ADDENDUM NO. 1

PROJECT TITLE: REHABILITATION OF BRIDGE NO. 00608 ROUTE 8 NB

DRAWING TITLE: GENERAL NOTES

PROJECT NO. 73-182
DRAWING NO. S-02
SHEET NO. 04.02.A1

PROJECT NO. 73-182
DRAWING NO. S-13
SHEET NO. 04.13.A1

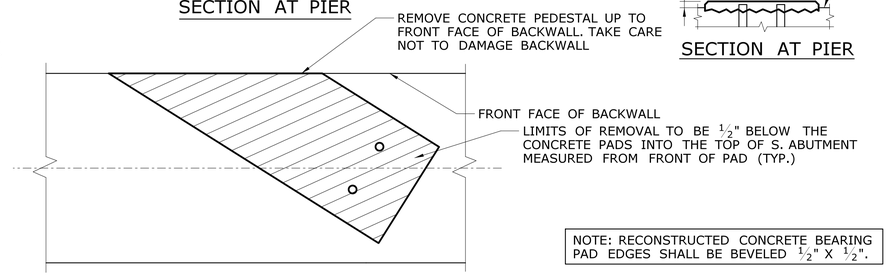
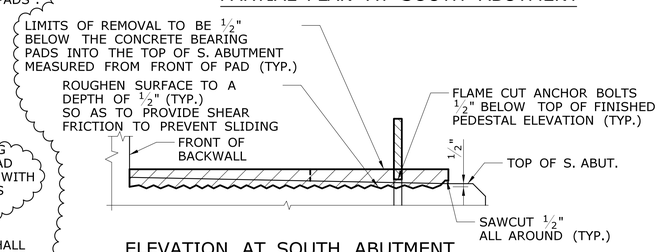
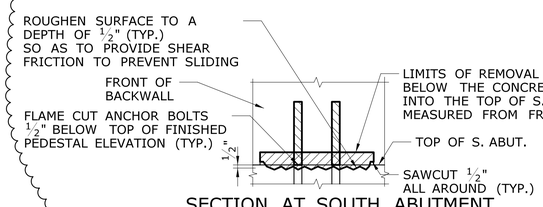
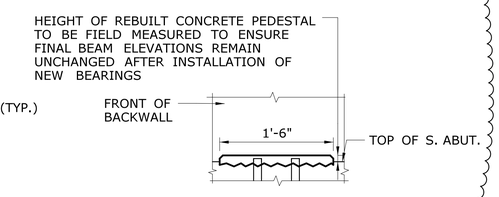
REV.	DATE	REVISION DESCRIPTION	SHEET NO.
1	06/23/2015	ADDED PAYMENT INFORMATION AND PAD RECONSTRUCTION	-

10. ALL CONCRETE BEARING PADS SHALL BE MODIFIED TO ACCOMMODATE THE NEW BEARING. ANY VARIATIONS OF THE CONCRETE BEARING PAD THAT EXCEED $\frac{1}{16}$" FROM A LEVEL SURFACE SHALL BE CORRECTED BY SAWCUTTING OR AS ORDERED BY THE ENGINEER. MODIFICATIONS TO CONCRETE BEARING PADS SHALL BE PAID FOR UNDER ITEM "MODIFY CONCRETE BEARING PADS" (1)

16. THE COST OF REMOVING THE EXISTING BEARINGS, AND FURNISHING AND INSTALLING THE ELASTOMERIC BEARINGS, INCLUDING THE LOAD PLATES, SHALL BE PAID FOR UNDER ITEM "BEARING REPLACEMENT WITH ELASTOMERIC BEARING PADS". OTHER STEEL COMPONENTS SUCH AS BOLSTERS AND SOLE PLATES SHALL BE PAID FOR UNDER ITEM NUMBER 0603061 - "STRUCTURAL STEEL (SITE NO. 1)". (1)

NOTE: RECONSTRUCTED CONCRETE BEARING PAD EDGES SHALL BE BEVELED ½" X ½". (1)

PROJECT NO. 73-182
DRAWING NO. S-14
SHEET NO. 04.14.A1

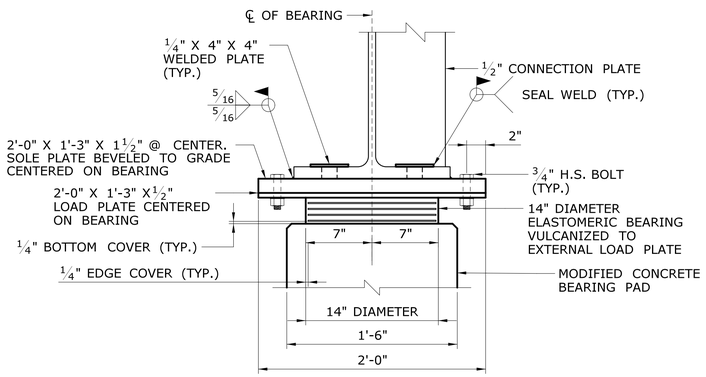
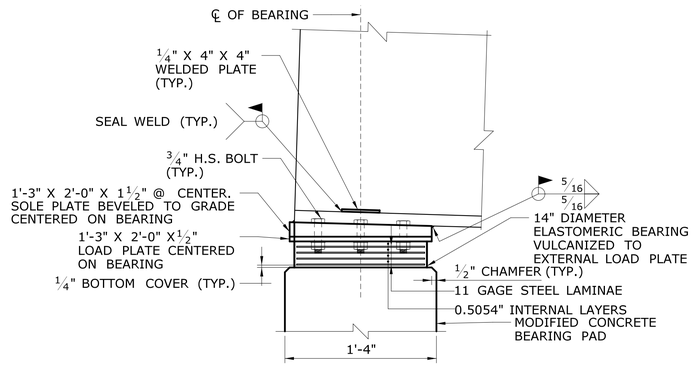
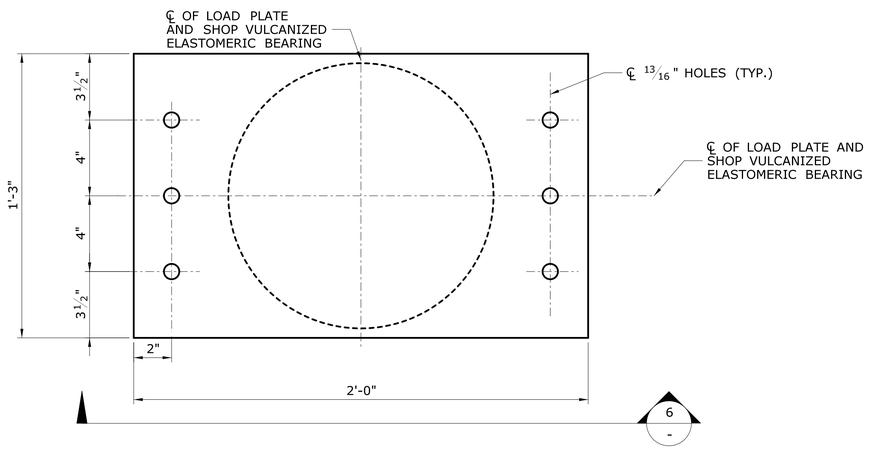
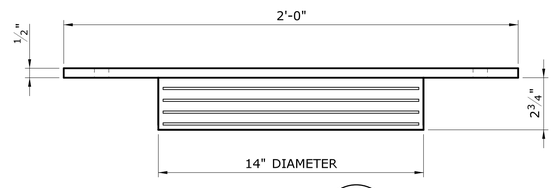
REV.	DATE	REVISION DESCRIPTION	SHEET NO.
1	06/23/2015	REVISED CALLOUTS AND ADDED NOTES	-

1. THE EXISTING ELEVATION OF THE BOTTOM FLANGE SHALL BE MAINTAINED THROUGHOUT THE BRIDGE.
2. THE ELEVATIONS FOR THE TOP OF CONCRETE PEDESTALS TO BE MODIFIED TO ACCOMMODATE THE NEW BEARING HEIGHT. ANY VARIATIONS OF THE CONCRETE BEARING PAD THAT EXCEED 1/16" FROM A LEVEL SURFACE SHALL BE CORRECTED BY GRINDING OR AS ORDERED BY THE ENGINEER.
3. THE EXISTING FIXED BEARING TOTAL HEIGHT = 3.75" & THE EXISTING EXPANSION BEARING TOTAL HEIGHT = 4.25" WHILE THE PROPOSED BEARING TOTAL HEIGHT = 4.75"
4. REFER TO S-13 FOR CONCRETE PAD MODIFICATION 1

PROJECT NO. 73-182
DRAWING NO. S-15
SHEET NO. 04.15.A1

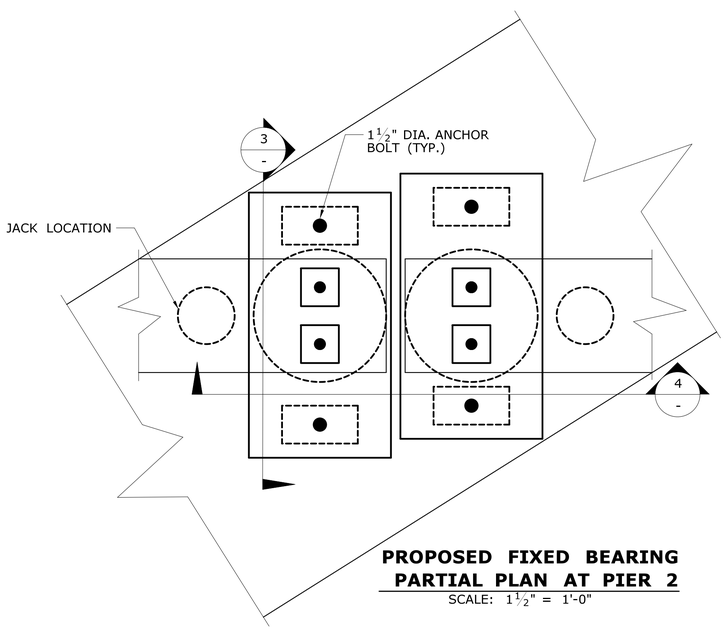
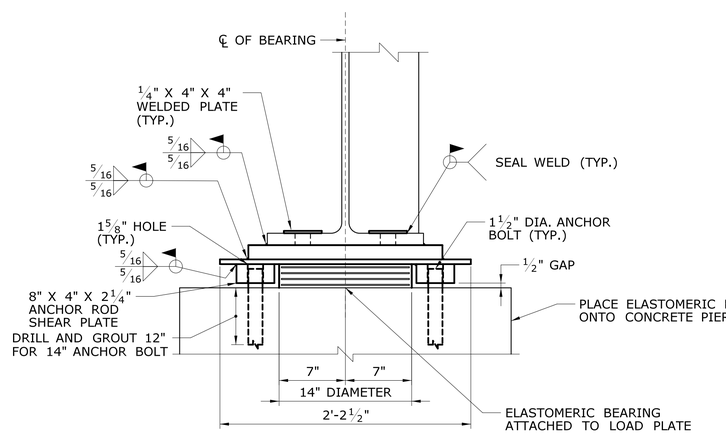
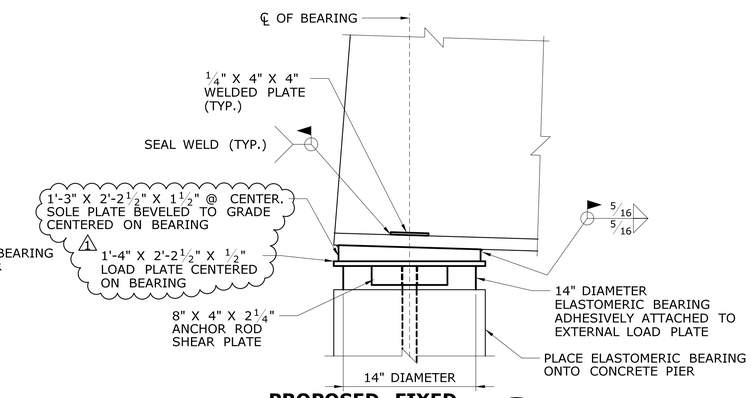
REV.	DATE	REVISION DESCRIPTION	SHEET NO.
1	06/23/2015	REVISED PLATE THICKNESSES, NOTES AND CALLOUTS	-

1. THE EXISTING ELEVATION OF THE BOTTOM FLANGE SHALL BE MAINTAINED THROUGHOUT THE BRIDGE.
2. THE ELEVATIONS FOR THE TOP OF CONCRETE PEDESTALS TO BE MODIFIED TO ACCOMMODATE THE NEW BEARING HEIGHT. ANY VARIATIONS OF THE CONCRETE BEARING PAD THAT EXCEED 1/16" FROM A LEVEL SURFACE SHALL BE CORRECTED BY GRINDING OR AS ORDERED BY THE ENGINEER.
3. THE EXISTING FIXED BEARING TOTAL HEIGHT = 3.75" & THE EXISTING EXPANSION BEARING TOTAL HEIGHT = 4.25" WHILE THE PROPOSED BEARING TOTAL HEIGHT = 4.75"
4. REFER TO S-13 FOR CONCRETE PAD MODIFICATION 1

PROJECT NO. 73-182
DRAWING NO. S-16
SHEET NO. 04.16.A1

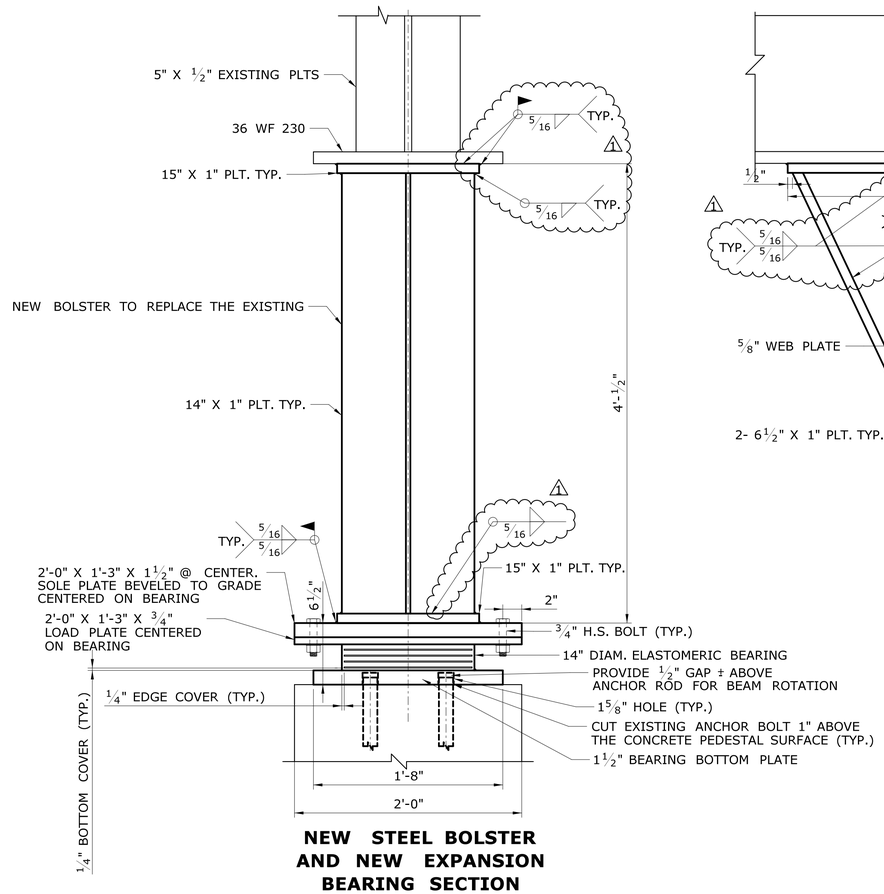
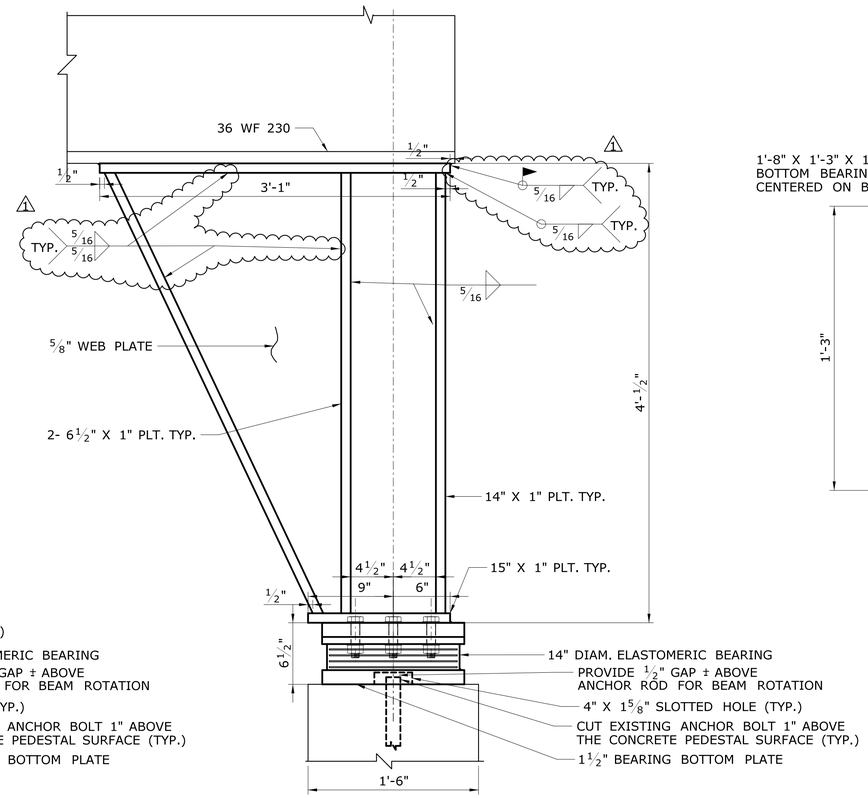
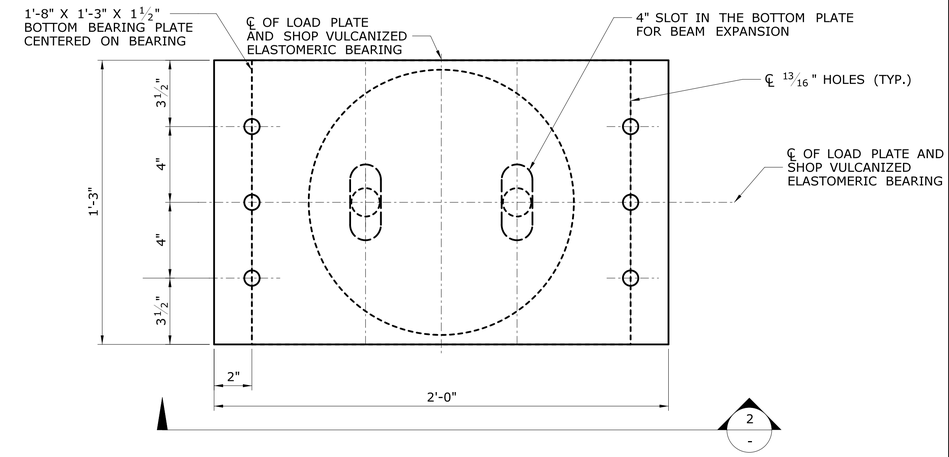
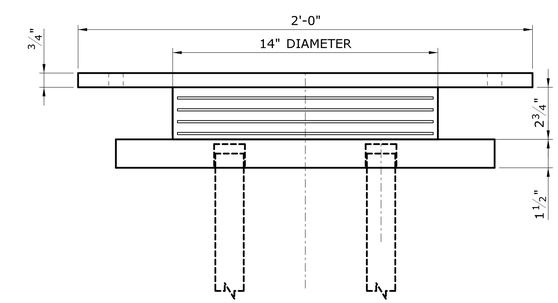
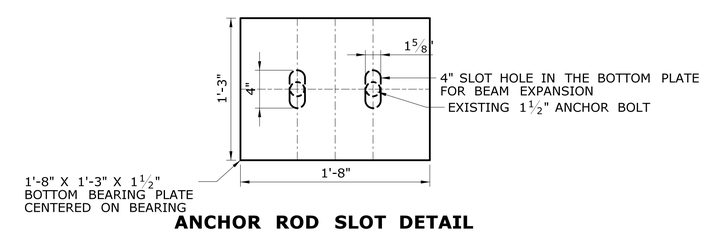
REV.	DATE	REVISION DESCRIPTION	SHEET NO.
1	06/23/2015	REMOVED FIELD WELDS	-

PROJECT NO. 73-182
DRAWING NO. S-41
SHEET NO. 04.41.A1

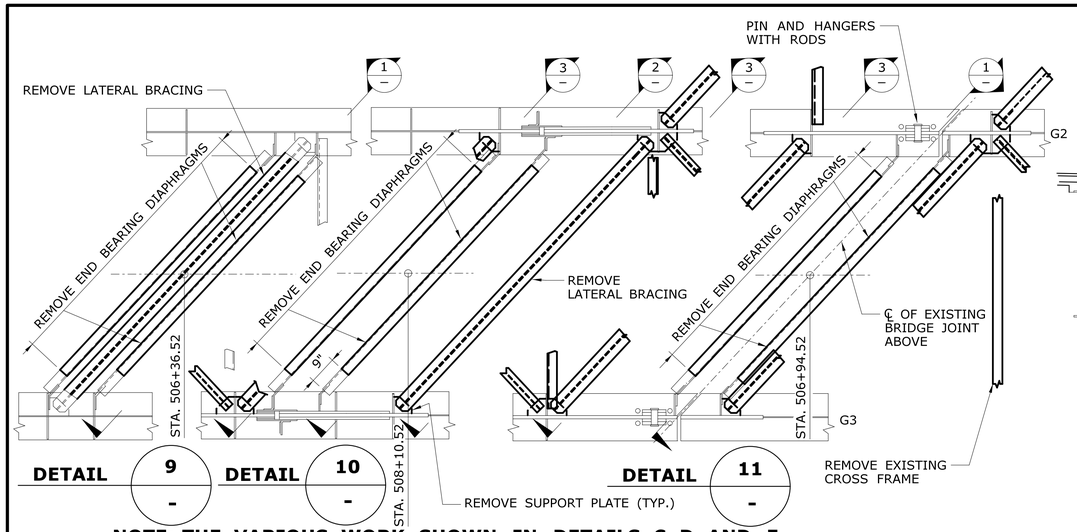
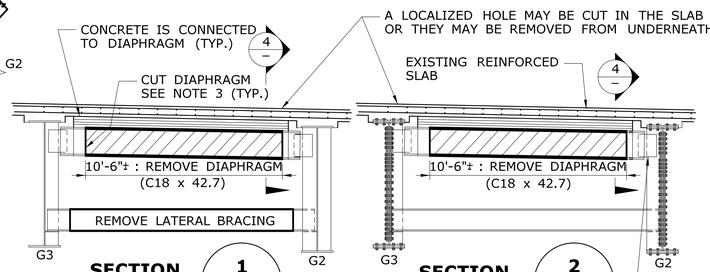
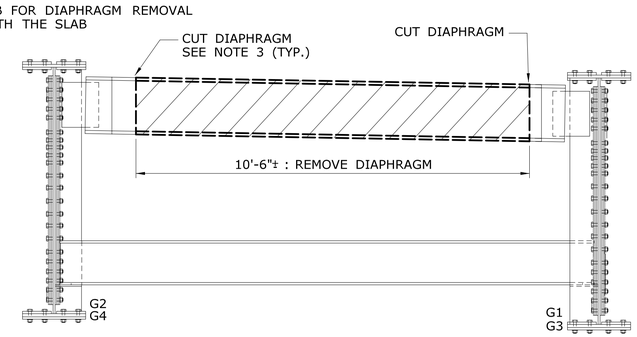
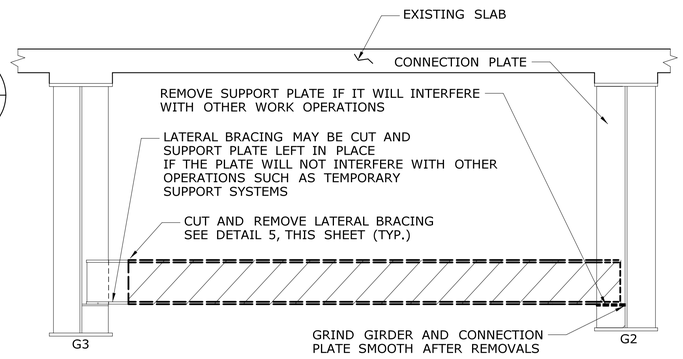
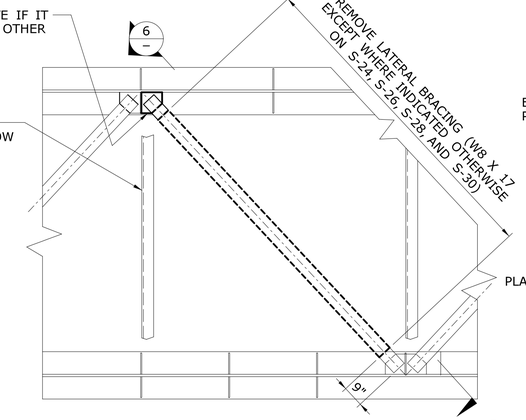
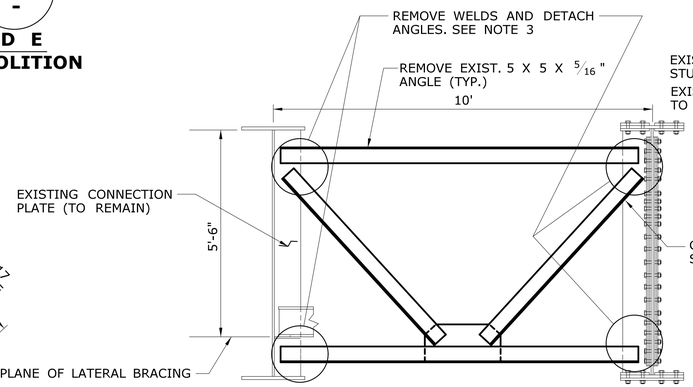
REV.	DATE	REVISION DESCRIPTION	SHEET NO.
△1	06/23/2015	REVISED PAYMENT	-

1) THE COST OF REMOVING OF EXISTING LATERAL BRACING, SUPPORT PLATES, AND END BEARING DIAPHRAGMS SHALL BE PAID FOR UNDER ITEM "REMOVAL OF EXISTING STRUCTURAL STEEL"

2) THE COST OF DISCONNECTING AND RECONNECTING END BEARING DIAPHRAGMS AND LATERAL BRACING SHALL BE PAID FOR UNDER ITEM "DISCONNECT AND RECONNECT EXISTING DIAPHRAGMS"

3) THE COST OF REMOVING LEAD BASED PAINT PRIOR TO ARC GOUGING, FLAME CUTTING, OR WELDING SHALL BE PAID FOR UNDER THE ITEM "LOCALIZED PAINT REMOVAL AND FIELD PAINTING OF EXISTING STEEL". △1

WHEN CROSS FRAMES ARE TO BE REINSTALLED THE WORK INDICATED IN DETAIL-15 AND 16 SHALL BE PAID FOR UNDER ITEM "DISCONNECT AND RECONNECT EXISTING CROSS FRAMES"

WHEN CROSS FRAMES WILL BE PERMANENTLY REMOVED, THE WORK INDICATED IN DETAIL-15 SHALL BE PAID FOR UNDER ITEM "REMOVAL OF EXISTING STEEL"

PROJECT NO. 73-182
DRAWING NO. S-44
SHEET NO. 04.44.A1

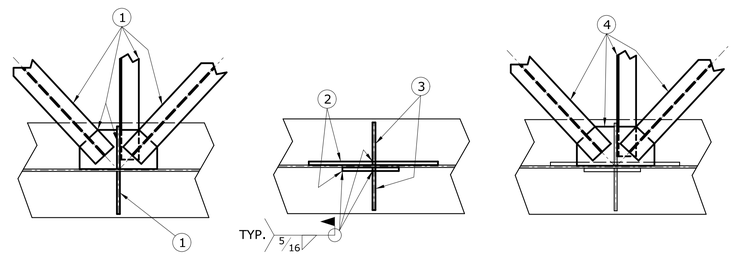
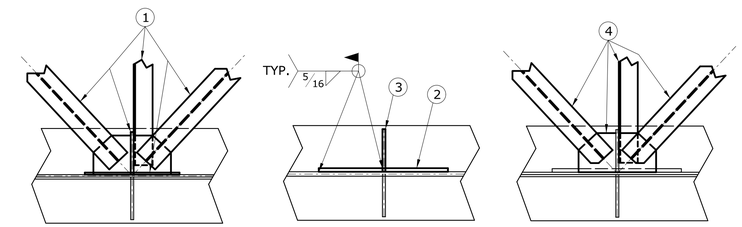
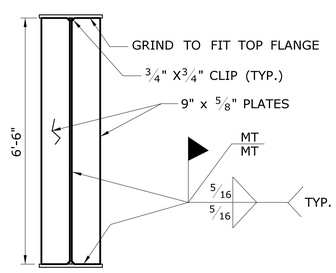
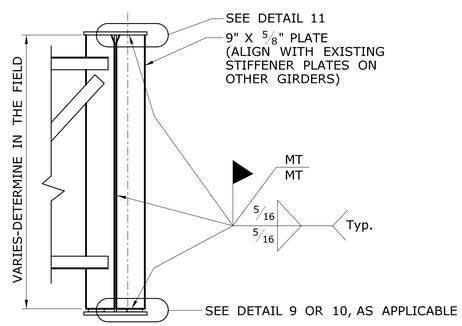
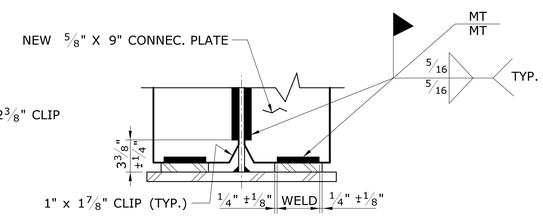
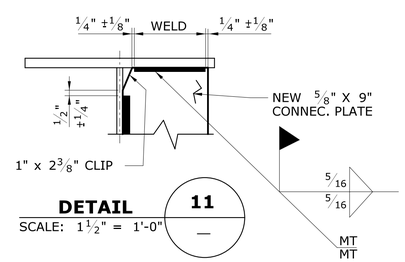
REV.	DATE	REVISION DESCRIPTION	SHEET NO.
⚠	6/23/2015	ADDED PAYMENT	-
-	-	-	-
-	-	-	-
-	-	-	-
-	-	-	-
-	-	-	-
-	-	-	-

⚠ NOTE 4: STEEL REPAIR PLATES FOR DETERIORATED AREAS SHALL BE PAID FOR UNDER THE ITEM "STRUCTURAL STEEL"

PROJECT NO. 73-182
DRAWING NO. S-45
SHEET NO. 04.45.A1

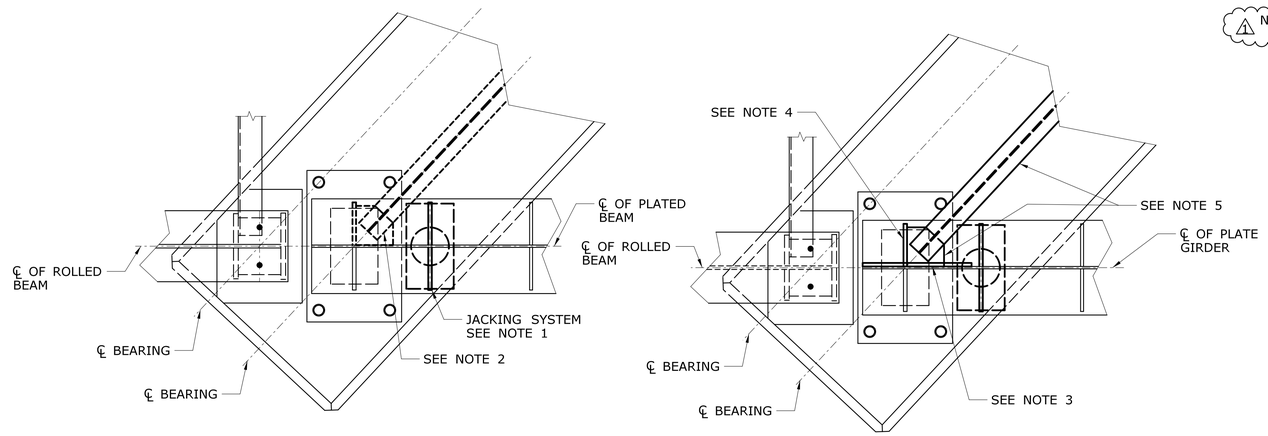
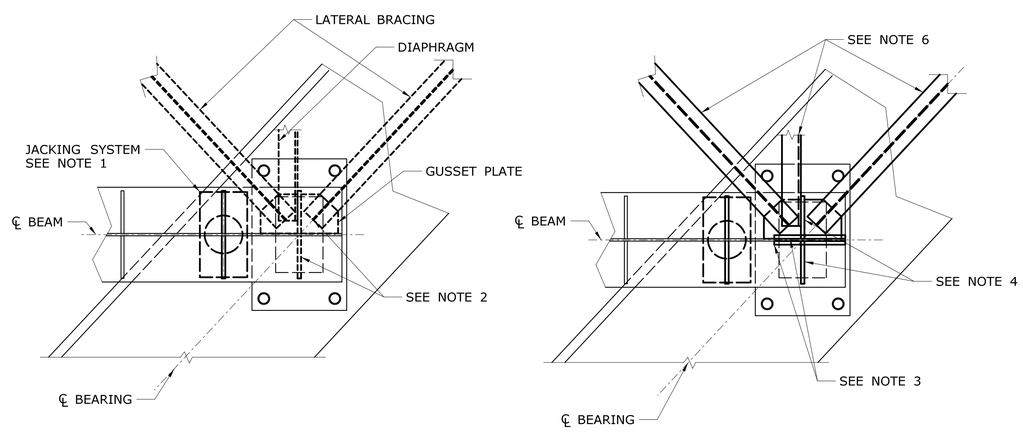
REV.	DATE	REVISION DESCRIPTION	SHEET NO.
△1	6/23/2015	ADDED PAYMENT	-
-	-	-	-
-	-	-	-
-	-	-	-
-	-	-	-
-	-	-	-
-	-	-	-

△1 NOTE 4: STEEL REPAIR PLATES FOR DETERIORATED AREAS SHALL BE PAID FOR UNDER THE ITEM "STRUCTURAL STEEL"
